## 25 Pine Ridge Road

### 4-Unit Multifamily Dwelling Conditional Use

This document, along with attached submissions, is a narrative response to staff reports, materials requests and public comments related to the Underhill Development Review Board's (DRB) consideration of DRB-2017-16, an application for a conditional use permit for a four unit multifamily dwelling at 25 Pine Ridge Road.

Water Conservation District, shown with streams layer.  
Source: CCRPC Underhill Map Viewer

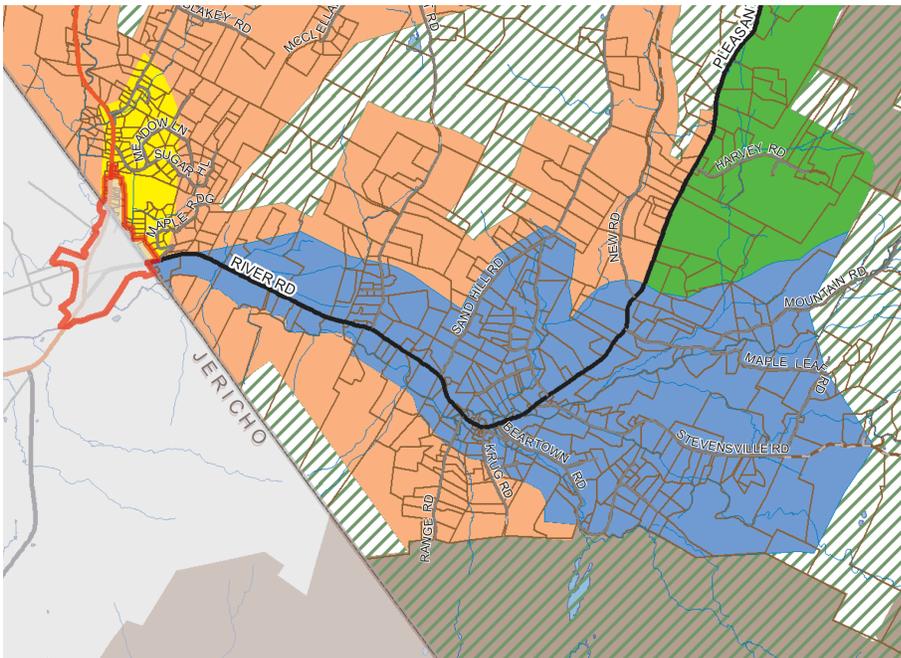
### Scale & Character

Scale and character are relative, requiring comparison to existing development. The proper context for character analysis is the Water Conservation Zone, which includes all of the Underhill Center intervale and much of the hillsides, following the tributaries of Browns River.

Massing study walkthrough, PR007

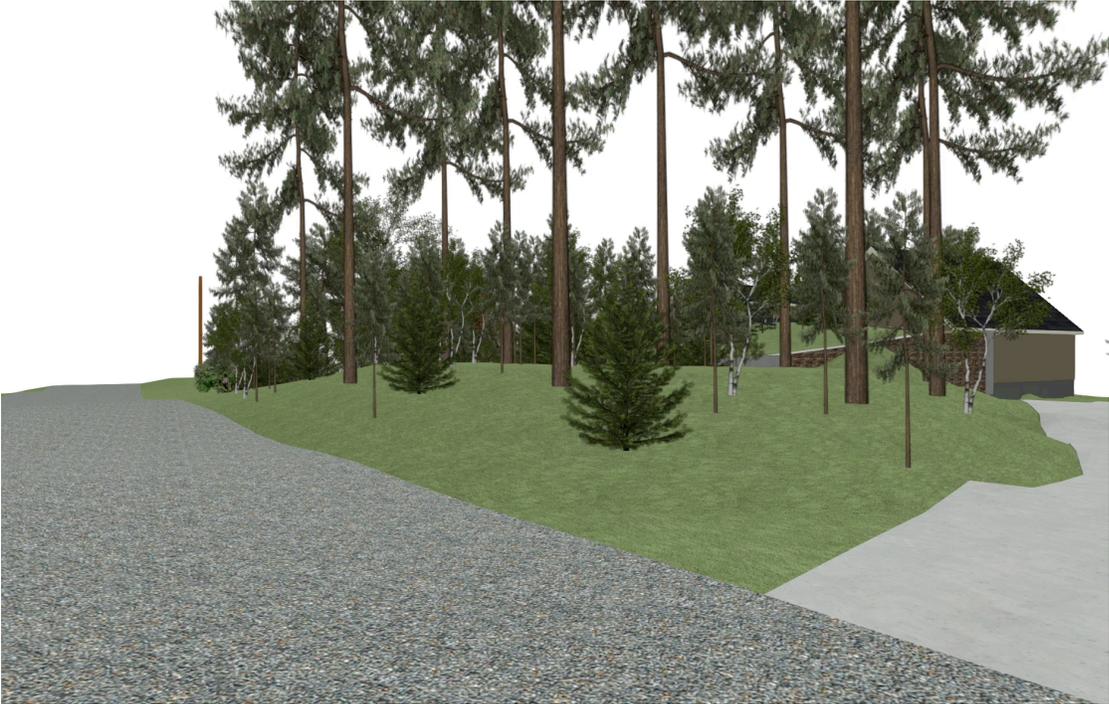
**Massing Study**

The massing study request has pushed the project's consultants to new areas of analysis. It has been quite an effort to produce the visuals that you will see. Property cards from the Assessor's office, air photos and roadside photos were used to create models of 26 buildings.

The massing study places 3D models of comparison properties in a model landscape at the project site. Walkthrough movies have been created for several of the models, demonstrating that the mass of the proposed project will be less visible than many existing properties in the area.
